Minute No. 221
Report – Standing Policy Committee on Property and Development, Heritage and Downtown Development – February 2, 2018

Item No. 8 **Request to Amend Agreement AG 36/04 (Addendum to Development Agreement AG 1/95) for 147 Nordstrom Drive – rear yard set-back – File Nos. AG 36/04 (DASZ 36/2004)**
(St. Boniface Ward)

Title: **Request to Amend Agreement AG 36/04 (Addendum to Development Agreement AG 1/95) for 147 Nordstrom Drive – rear yard set-back – File Nos. AG 36/04 (DASZ 36/2004)**

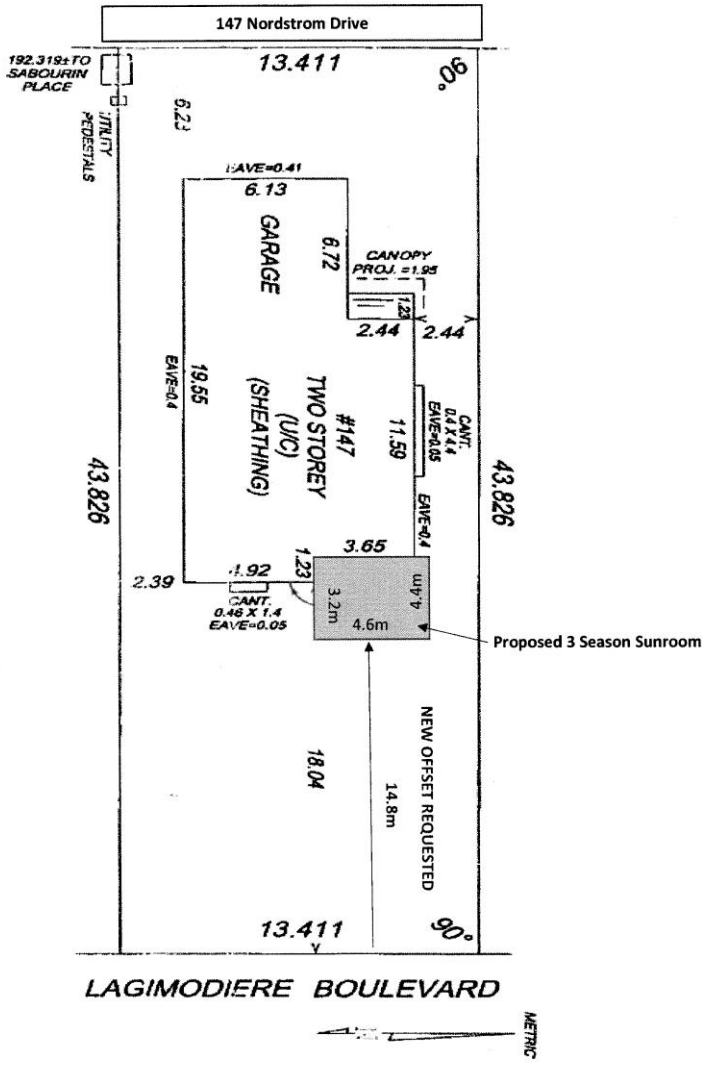
We would like to request, for consideration, an amendment to the Development Agreement caveated to our lot as it relates to the minimum rear yard setback of 17.5 m. Specifically, we are requesting that the current minimum rear yard setback of 17.5 meters be amended to 14.8 meters to allow for the construction of a 3-season sunroom.

In an effort to facilitate our request, we have attached a copy of our current status of title, along with a plan view sketch overlaid onto our surveyor's building location certificate to demonstrate the location and measurements of the proposed 3-season sunroom and new rear yard off-set.

147 Nordstrom Drive
192.319±TO SABOURIN PLACE
UTILITY PEDESTALS
13.411
90°
6.22
EAVE=0.41
6.13
GARAGE
6.72
CANOPY PROJ. =1.95
1.23
2.44
2.44
EAVE=0.4
19.55
TWO STOREY (U/C) (SHEATHING)
#147
11.59
CANT. 0.4 X 4.4 EAVE=0.05
43.826
43.826
EAVE=0.4
3.65
1.23
1.92
2.39
CANT. 0.46 X 1.4 EAVE=0.05
3.2m
4.6m
4.4m
Proposed 3 Season Sunroom
NEW OFFSET REQUESTED
14.8m
18.04
13.411
90°
LAGIMODIERE BOULEVARD
METRIC

"9.1 Notwithstanding Clause 9 of this agreement, the proposed sunroom addition to the rear of the existing dwelling on Lot 37, Block 1, Plan 44824 shall be set back a minimum distance of 14.8 metres from the rear property line abutting the boundary of Lagimodiere Boulevard (formerly Melnick Road) instead of 17.5 metres."
